# Duquesne Light Company

Reference: Beaver Valley Power Station, Unit No. 1  
Docket No. 50-334, License No. DPR-66  
Inservice Inspection Program Revisions

Relief Request No. BV1-CH-E-2-1, Rev. 0

Relief Request No. BV1-CH-E-3-1, Rev. 0

## LETDOWN CUBICLE PAB 722'

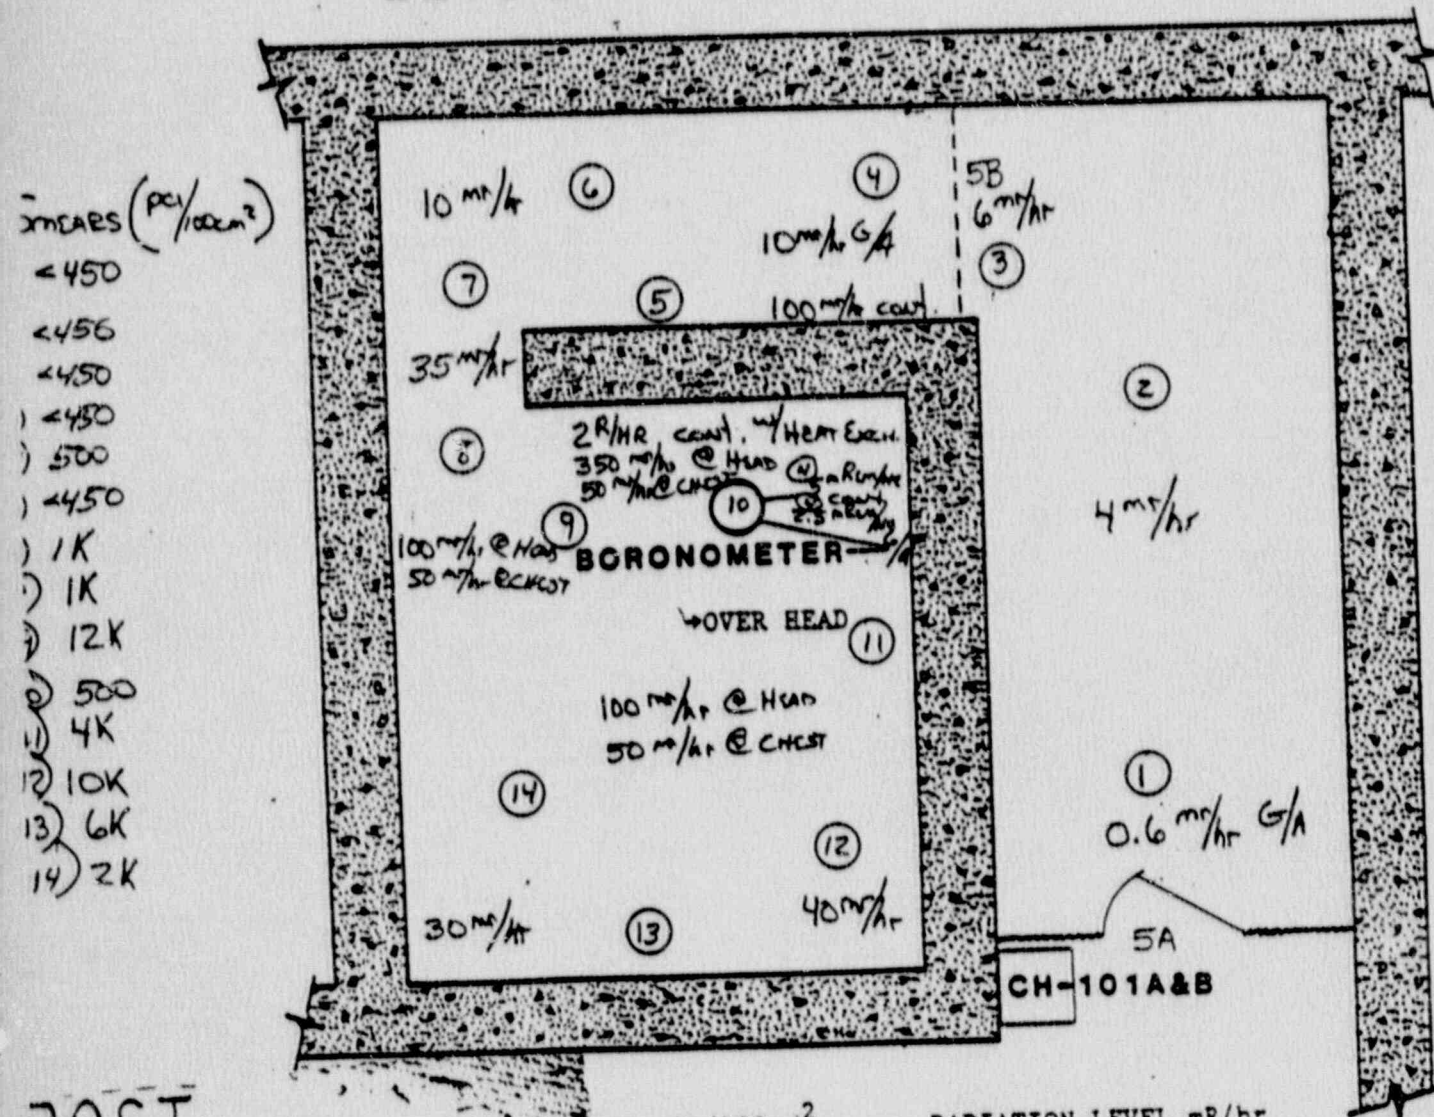
The general radiation level in the area of the Non-Regenerative Heat Exchanger is 350 mRem/hr; contact readings are 2 Rem/hr. These readings were recorded in the attached May 8, 1990 survey. The manrem estimate to prepare, inspect, and reinsulate these welds is projected to be 18.5 Rem. This total is based on dose rates and approximate work durations noted in the attached manrem estimate. This estimate represents an optimum work schedule, any difficulties encountered would increase the doses.

NON REGENERATIVE LETDOWN  
HEAT EXCHANGER

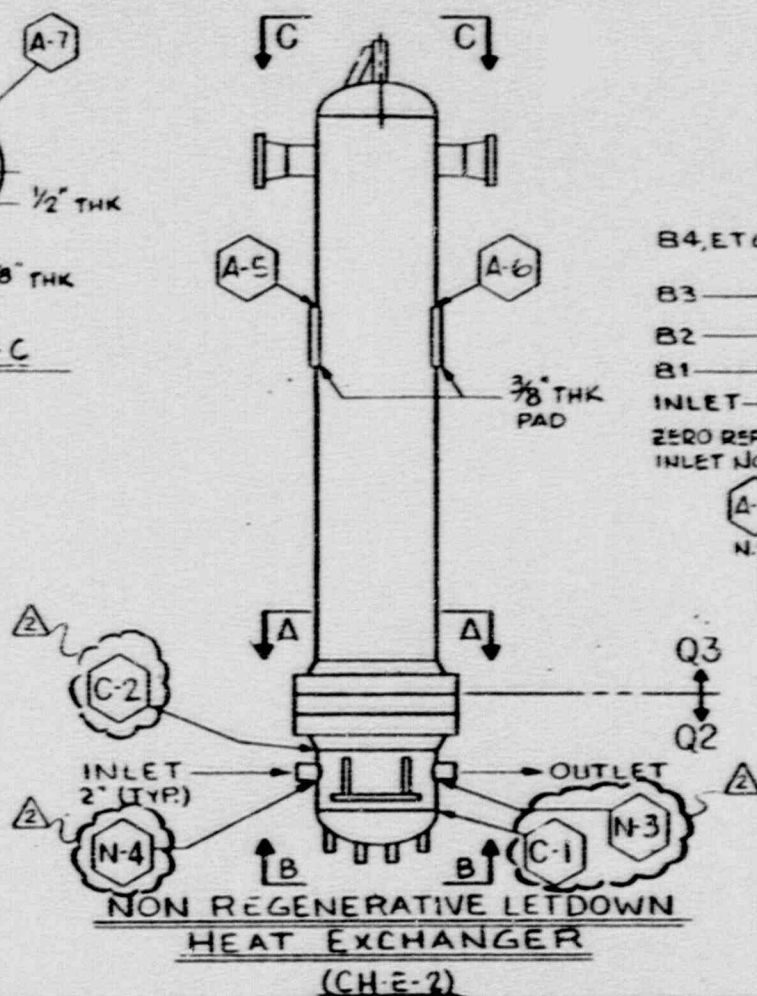
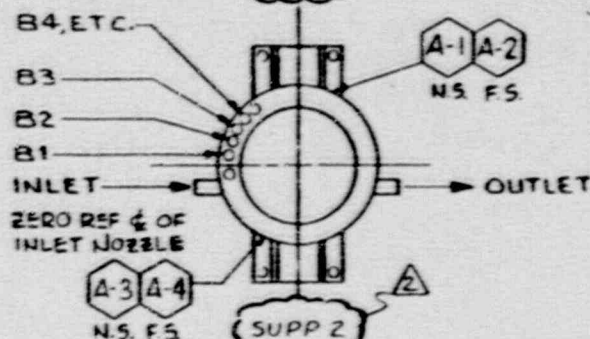
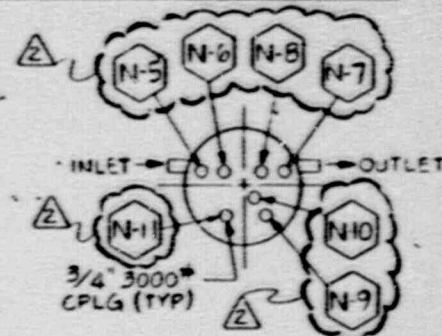
Non-Regenerative Heat Exchanger (CH-E-2) welds C-1 and C-2 and welded attachments A-1, A-2, A-3, and A-4.

Table IWC-2500-1, Category C-A, Item No.'s C1.10 and C1.20 require volumetric examination of 100% of welds C-1 and C-2. Item C3.10 requires surface examination of the welded attachments.

The proposed (alternative) visual examination for leakage is a more practical examination for monitoring the integrity of the components than the Code required examination. The required examinations are of limited value because component geometry limits the volumetric examination of welds C-1 and C-2 to one side only. The endcap-to-vessel weld (weld C-1) cannot be examined from the endcap side and the flange-to-vessel weld (weld C-2) cannot be examined from the flange side. In addition, the proximity of the vessel supports, inlet and outlet nozzles and weld crown further limit the one-sided examination by limiting search unit approach distance. These restrictions make it difficult to obtain meaningful results from the volumetric examination of these welds. The affected welds are double-V butt welds in 0.625", SA-240 (Type 304) stainless steel in a vessel head of 27" outside diameter. Drawing 8700-ISI-E-003B is attached for information.

Visual examination (VT-2) for leakage during the performance of the system leakage examinations performed each 40-month period. This is augmented by radwaste monitoring, radiation surveys, and OST 1.6.2 and OST 1.48.2.

# REGENERATIVE HEAT EXCHANGER (CHE-3)

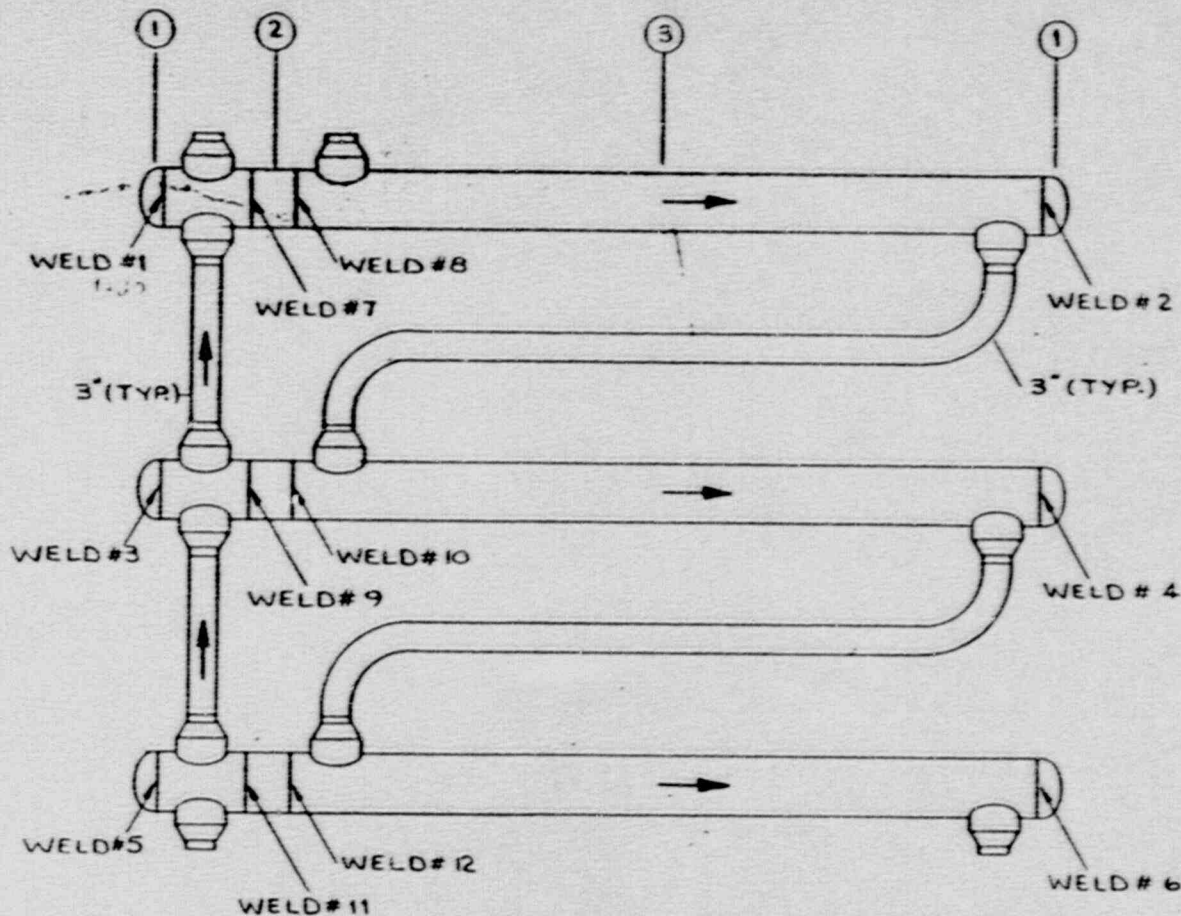
Regenerative Heat Exchanger (CH-E-3) welds 1 through 12.

Table IWC-2500-1, Category C-A, Item No.'s C1.10 and C1.20 require volumetric examination of 100% of these welds.

The general radiation level in the area of the Regenerative Heat Exchanger is between 500 mRem/hr and 2 Rem/hr (See attached survey dated 9/4/89). The manrem estimate to prepare, inspect, and reinsulate these welds is projected to be 84 Rem. This total is based on dose rates and approximate work durations noted in the attached manrem estimate. This estimate represents an optimum work schedule, any difficulties encountered would increase the doses.

The proposed (alternative) visual examination for leakage is a more practical examination for monitoring the integrity of the components than the Code required examination. The required examinations are restricted because of component geometry limitations. Weld crown, nozzles, end cap curvature, welded attachments and vessel support structure all contribute to limiting weld volumetric examinations to varying degrees (See attached drawings). Previous examinations did not document the percentage of exam limitations. Current radiation levels prohibit limitation measurement.

This heat exchanger has an outside diameter of 9.55 inches and consists of three types of materials: .900" T SA-240 TP 304, .938" T SA-182 TP 304 and .938" T SA-351 CF8. See attached drawing for location of each material.

Visual examination (VT-2) for leakage during the performance of the system leakage examinations performed each 40-month period. This is augmented by radwaste monitoring and OST 1.6.2.
